To: T10 Technical Committee  
From: Bob Sheffield ([Robert.L.Sheffield@Intel.com](mailto:Robert.L.Sheffield@Intel.com)), Intel Corporation  
Date: November 5, 2002  
Subject: T10/02-435r3, SAS STP Buffering

### **Overview**

**Figure xx** – Expander device buffering & HOLD/HOLDA handshake (transfer in)

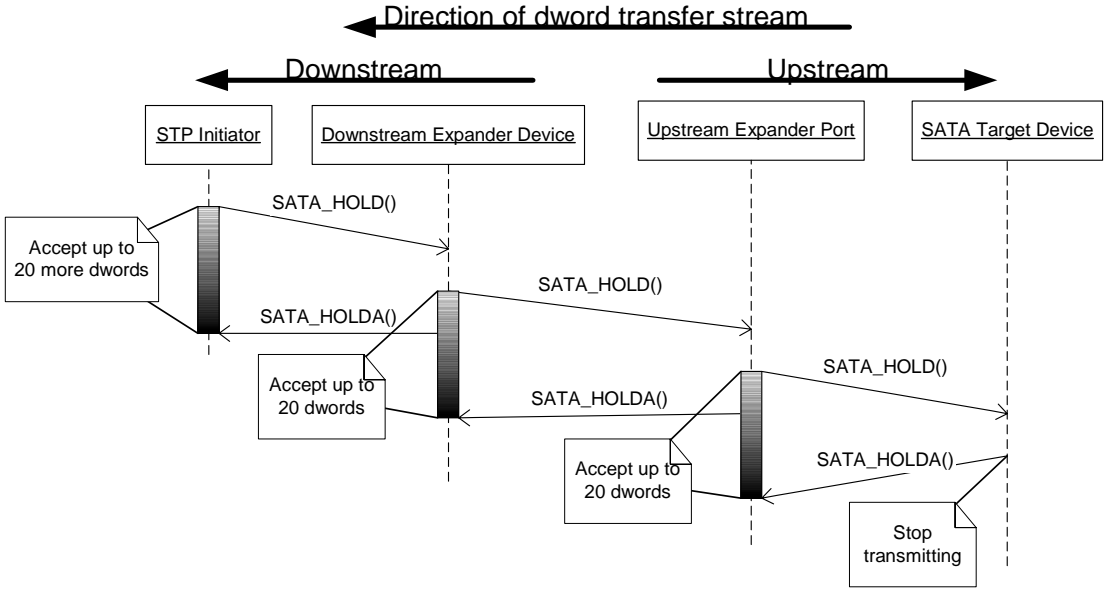
Each expander device along the pathway of an STP connection between an STP initiator port and a SATA target device shall follow the SATA SATA\_HOLD / SATA\_HOLD\_A protocol to implement flow control across every link in the pathway along the connection. The requirement applies to transfers in either direction. If an expander device receives a SATA\_HOLD from the downstream phy receiving a stream of dwords from the expander device the expander device shall stop sending data to the downstream phy and shall transmit SATA\_HOLD\_A to the downstream phy. The number of dwords transmitted to the downstream phy between the time the downstream phy sends SATA\_HOLD and the time the expander sends SATA\_HOLD\_A to the downstream phy shall be no more than 20.

Upon receiving a SATA\_HOLD from the downstream phy, an expander device shall propagate the SATA\_HOLD to the next upstream phy along the pathway of the connection, and shall accept up to 20 more dwords from the upstream phy before receiving SATA\_HOLD\_A from the upstream phy. If the expander device issues SATA\_HOLD\_A to the downstream phy before receiving SATA\_HOLD\_A from the next upstream phy along the pathway of the connection, the expander device shall maintain dwords received from the upstream phy during that interval in an internal buffer until the downstream phy is again ready to receive dwords. The expander may delay sending of SATA\_HOLD\_A to the downstream phy to minimize the number of dwords it must store in an internal buffer if it can do so without exceeding the 20 dword SATA\_HOLD\_A turnaround time on the link to the downstream phy.

Figure xx shows the propagation of the SATA\_HOLD primitive upstream through the pathway of an STP connection, the SATA\_HOLD(A) reply of each expander along the pathway, and the interval during which each expander must accept incoming dwords. In this case the time to propagate the SATA\_HOLD primitive to the next upstream phy is hidden behind the processing time to turnaround SATA\_HOLD(A) to the downstream phy, so the expander need only accept up to 20 additional dwords to account for the SATA\_HOLD(A) turnaround time of the next upstream phy.

**Figure xx** – Expander device buffering & HOLD/HOLDA handshake (transfer out)

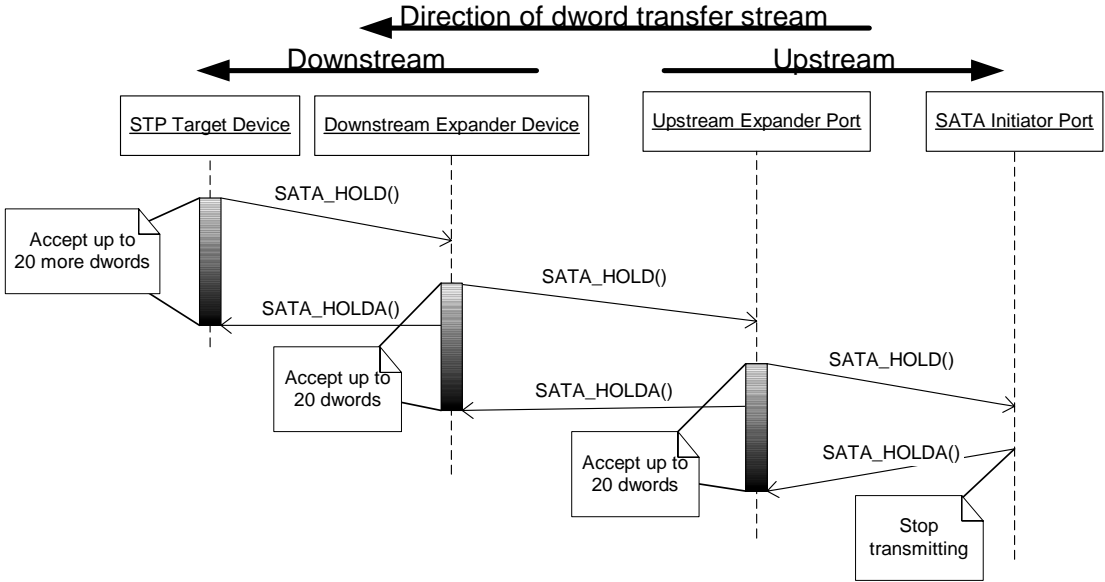
Figure xx shows the SATA\_HOLD/SATA\_HOLD\_A handshake and dword buffering for two stages of expander devices along the pathway of an STP connection transferring data from a SATA initiator port to a SATA target device. The flow-control protocol is completely symmetrical as compared to the transfer-in shown in the previous diagram.
